April 4, 2023

**RE: Prairie Point Site Plan No 1 (Kings Point North) Third Submission Review Response to Comments**

PRAIRIE POINT FILING 1	SITE PLAN COVER SHEET
DATE: 01/23/2023	
JOB NO: 12187.62	
SCALE AS NOTED	
1 of 54

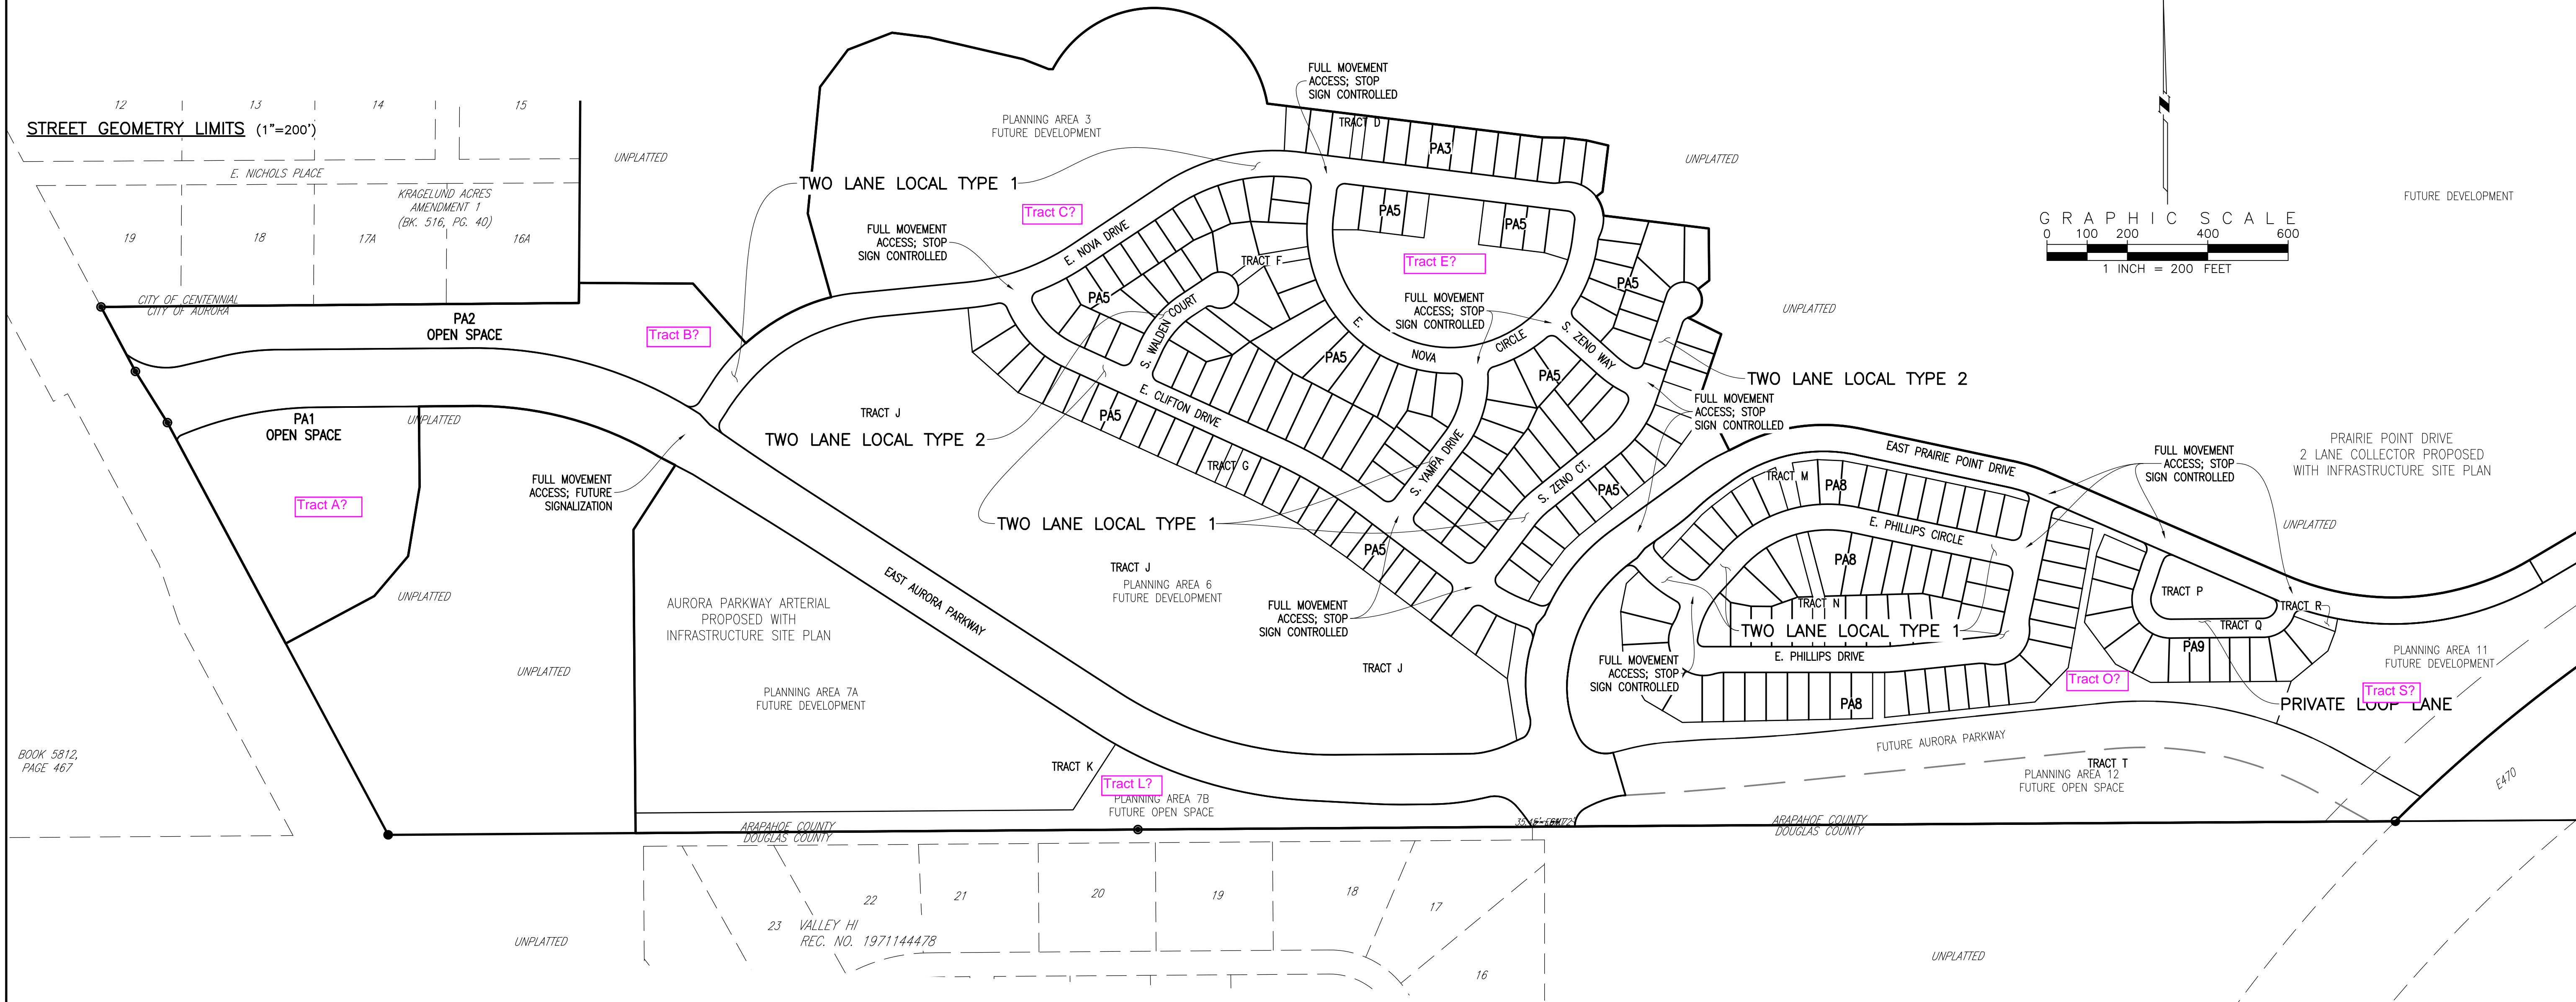
ALL REQUESTED TRACT LABELS  
HAVE BEEN ADDED

DESIGNED BY: JWM	DRAWN BY: JS	CHECKED BY: BOM	APPROVED BY: BOM
PRAIRIE POINT FILING 1			
DATE: 01/23/2023			
JOB NO: 12187.62			
SCALE HORIZONTAL 1" = 40'			
7 of 54

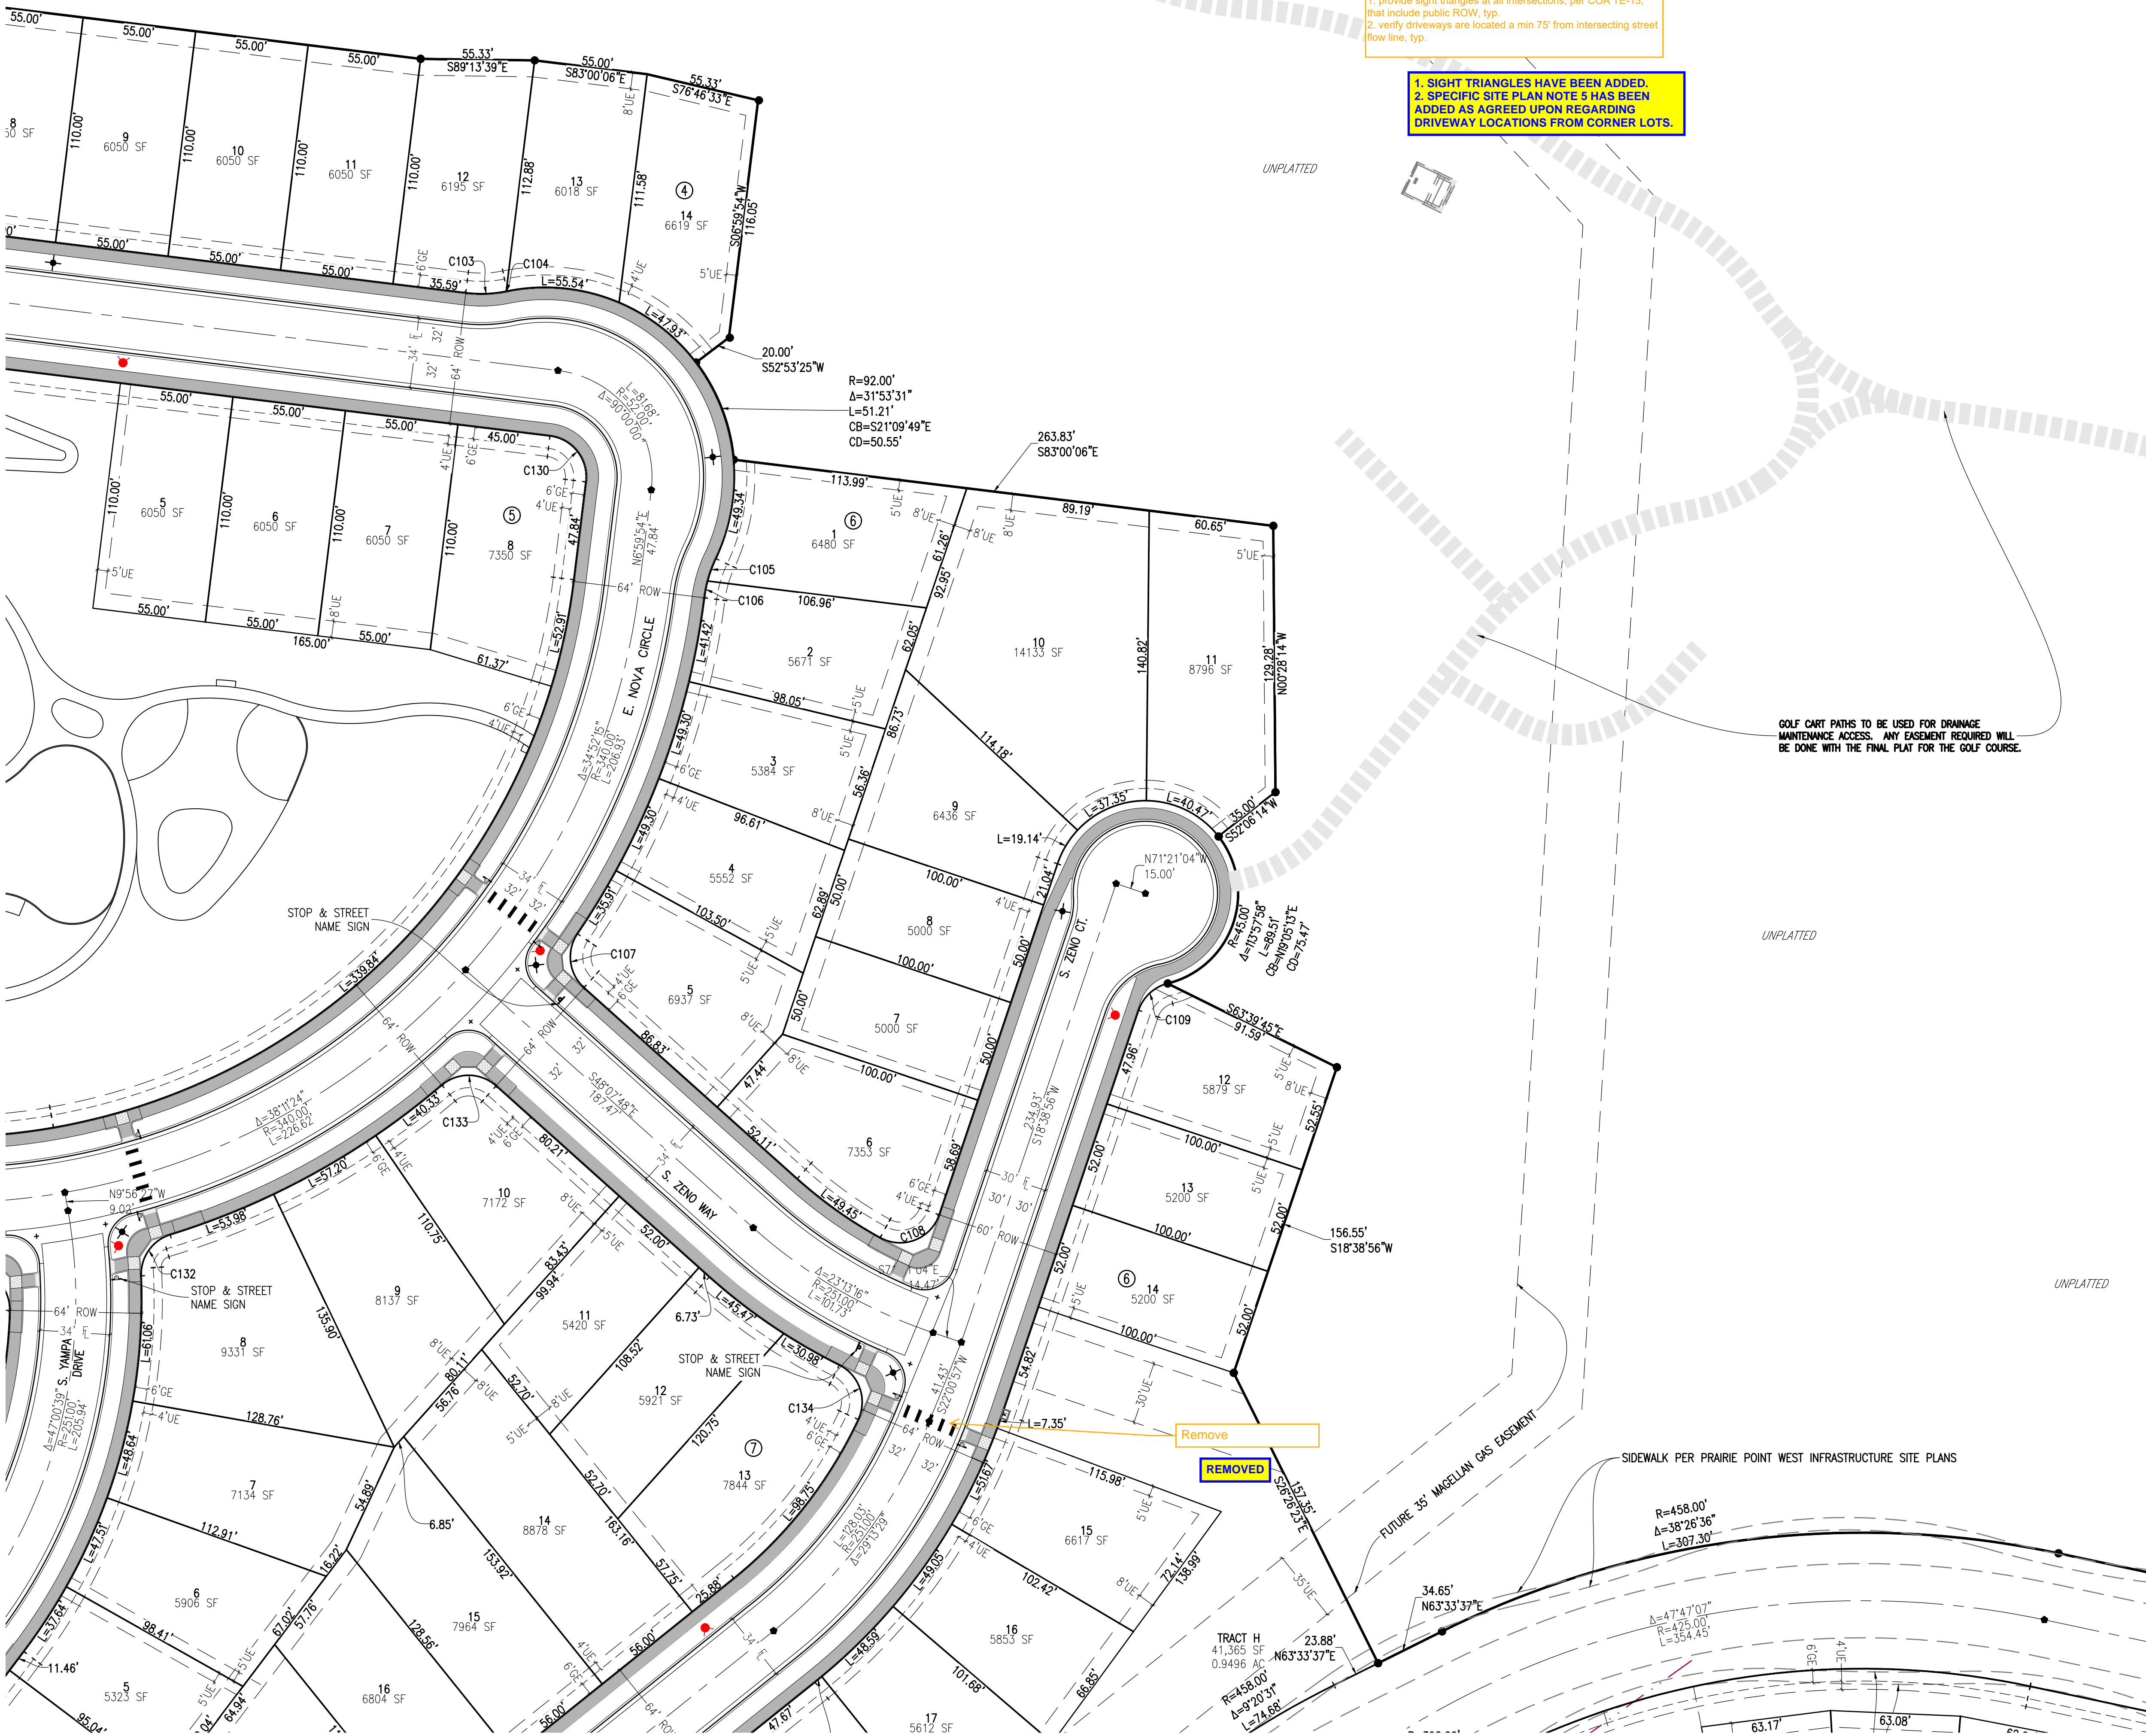
1. provide sight triangles at all intersections, per COA TE-13, that include public ROW, typ.  
2. verify driveways are located a min 75' from intersecting street flow line, typ.

DATE: 01/23/2023  
JOB NO: 12187.62  
SCALE: 1" = 40'  
11 of 54

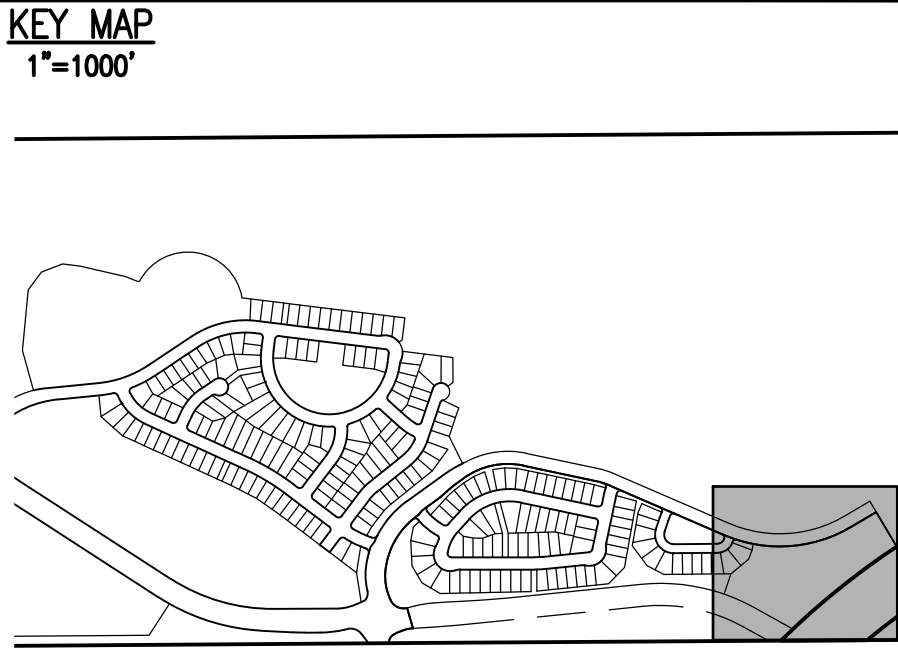
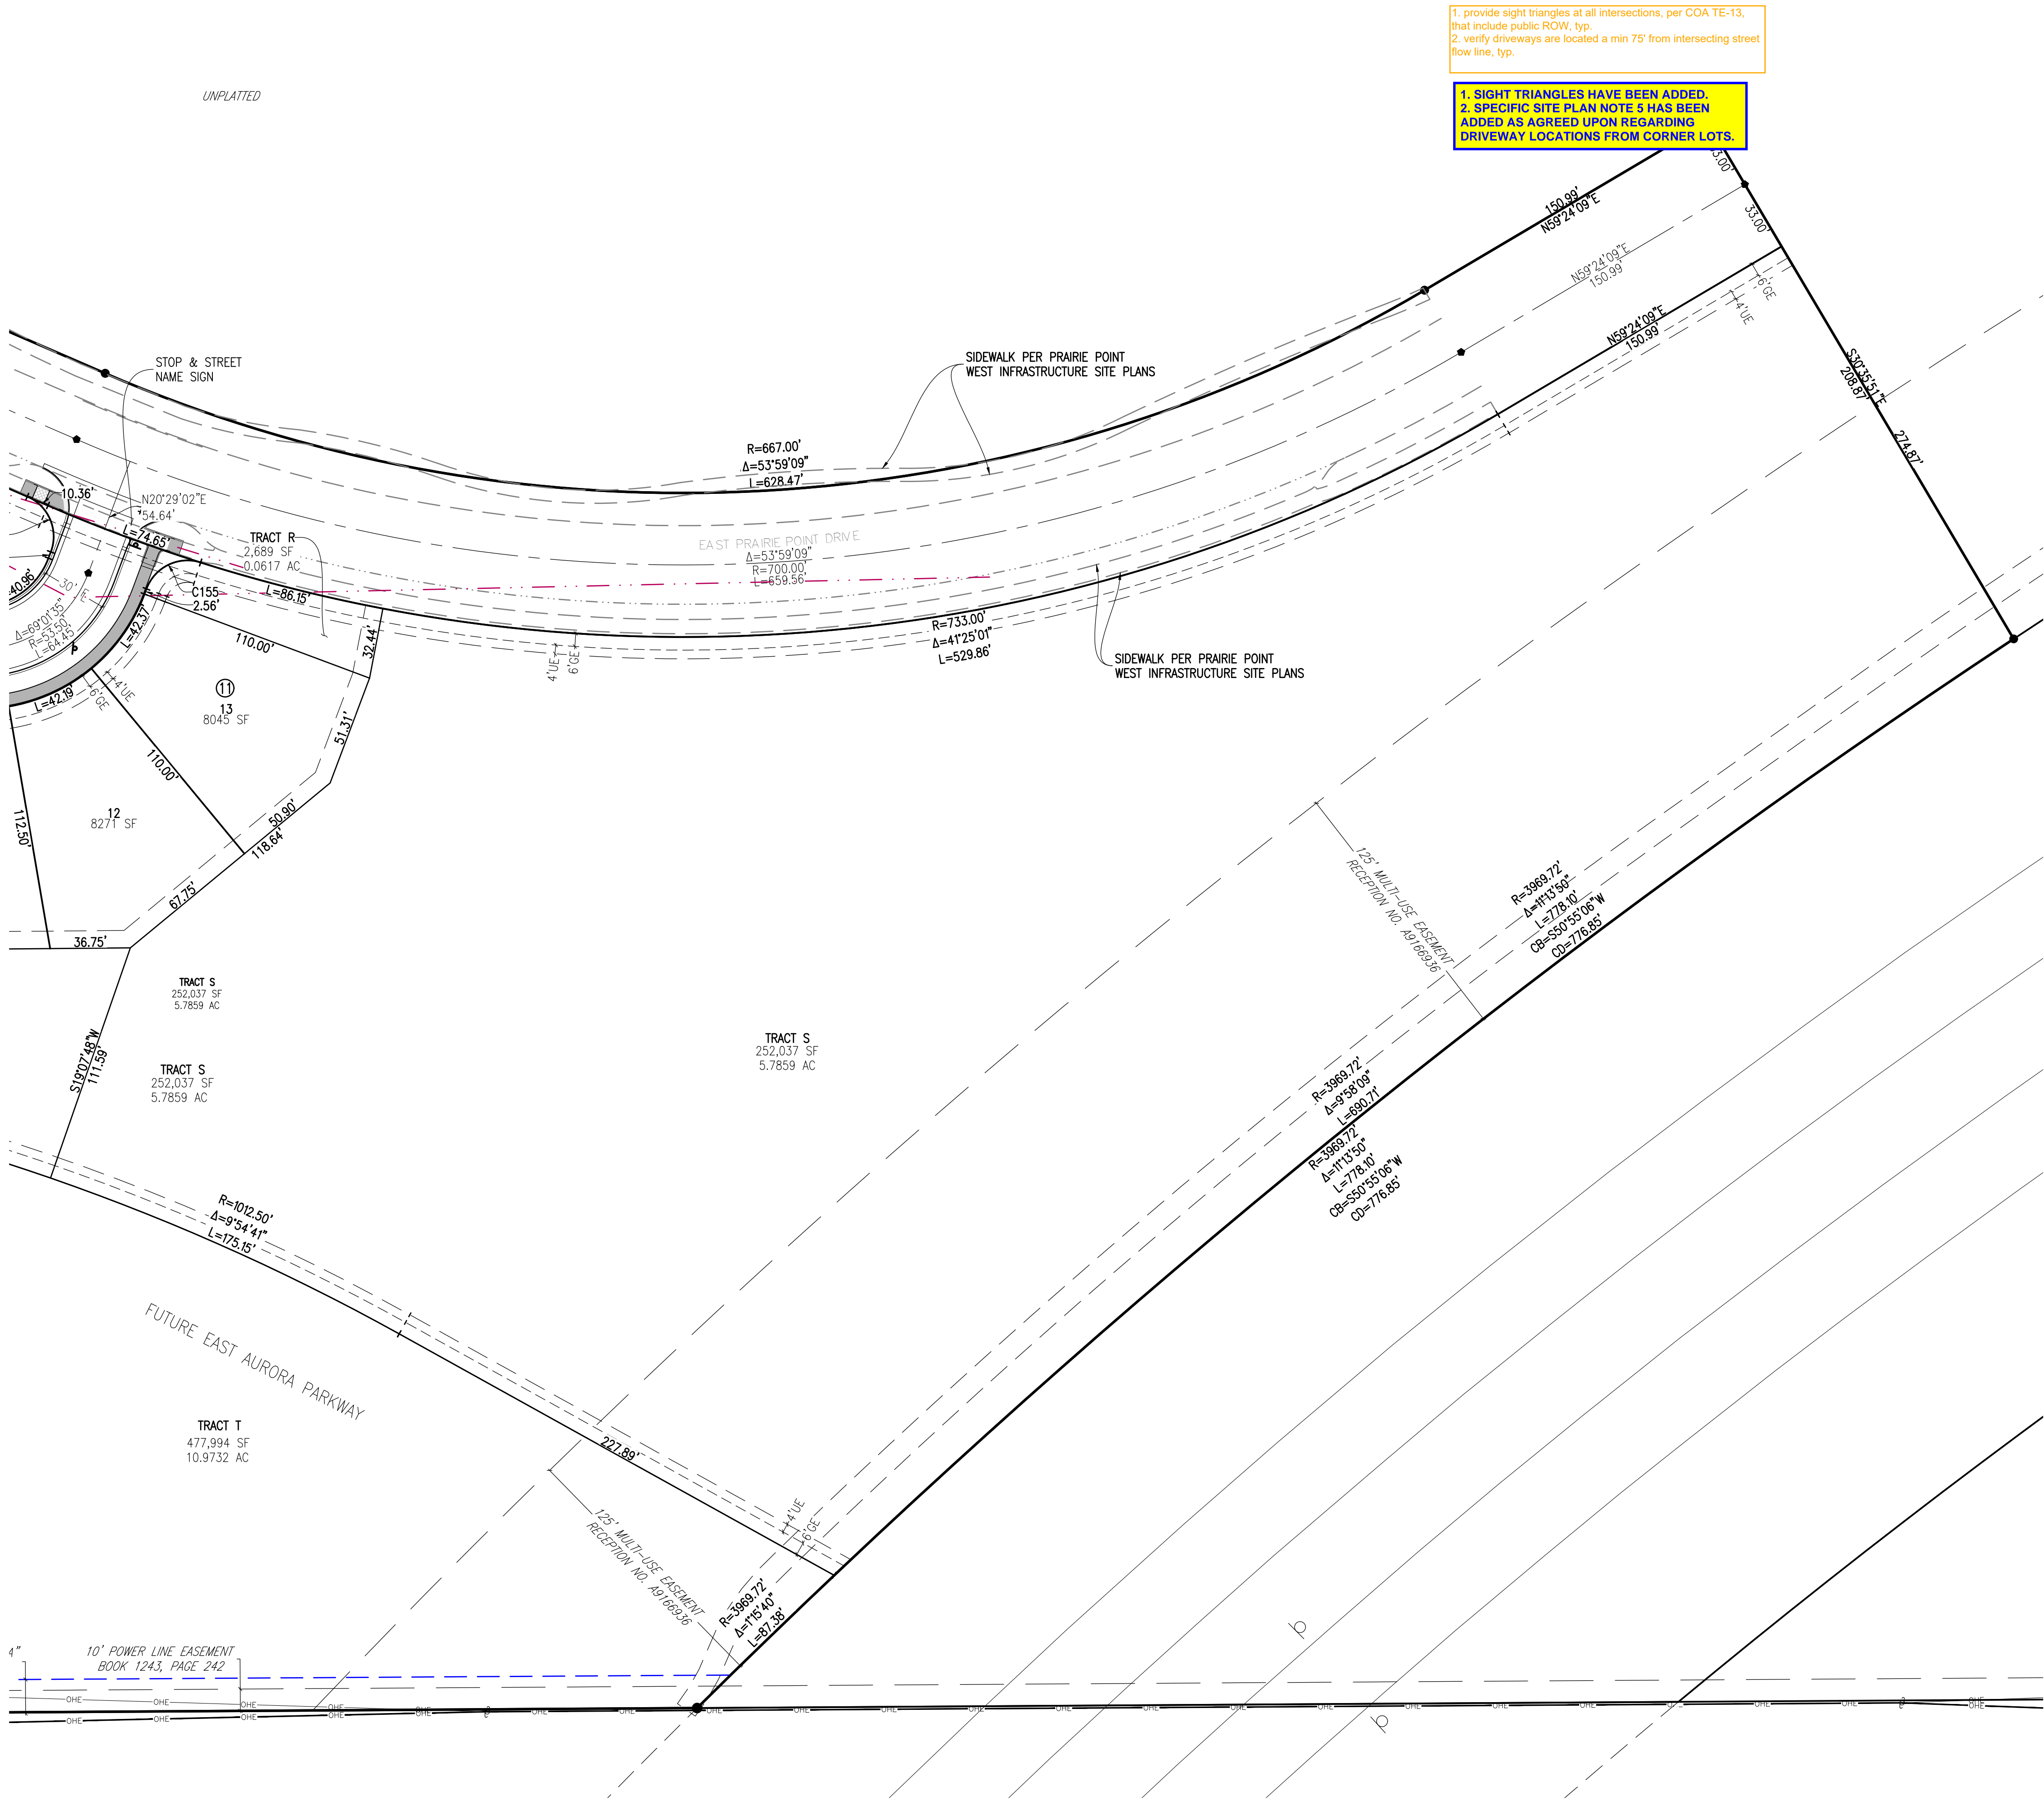
1. provide sight triangles at all intersections, per COA TE-13, that include public ROW, typ.  
2. verify driveways are located a min 75' from intersecting street flow line, typ.
1. SIGHT TRIANGLES HAVE BEEN ADDED.  
2. SPECIFIC SITE PLAN NOTE 5 HAS BEEN ADDED AS AGREED UPON REGARDING DRIVEWAY LOCATIONS FROM CORNER LOTS.
